MEMORANDUM

SUBJECT: BZA Case 19046 – 1511 28th Street, S.E.

Figure 2. Site Plan. Because the southern side yard should be measured from the farthest extension of the bay, that side yard dimension is significantly less than indicated by the applicant. OP has requested additional information from the applicant.

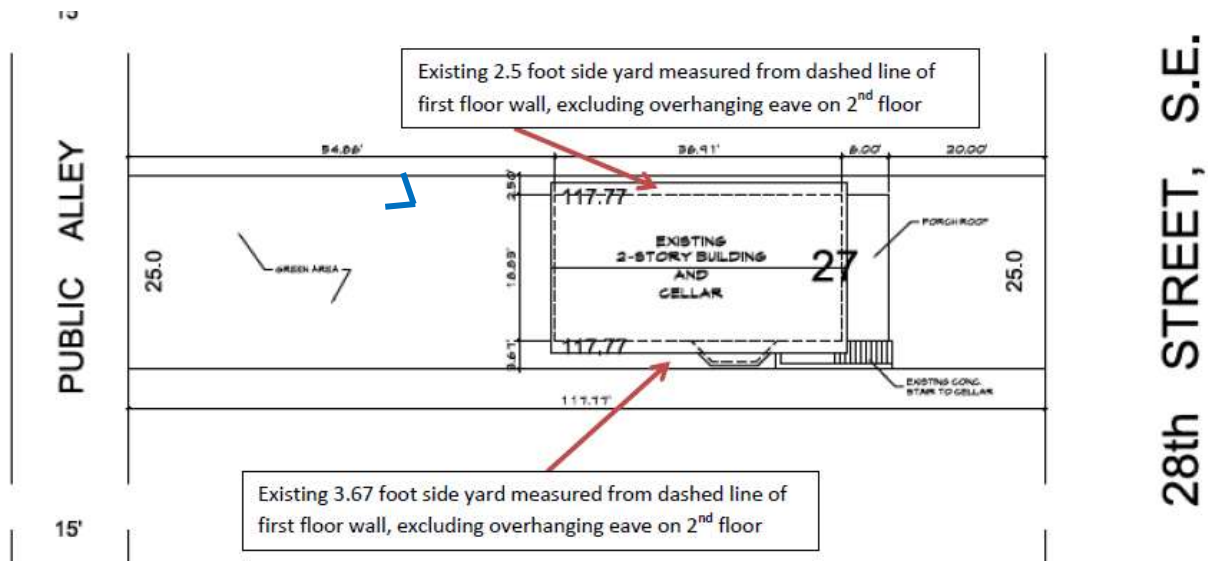
- § 405.1, Side Yard [8 feet required; approximately 6 inches to 1 foot provided on south side (clarification of dimension has been requested of the applicant)].

The applicant has submitted elevations, floor plans and photographs that illustrate the addition and its surroundings. Additional graphical materials is needed to clarify the width of the side yard on the south side of the house.
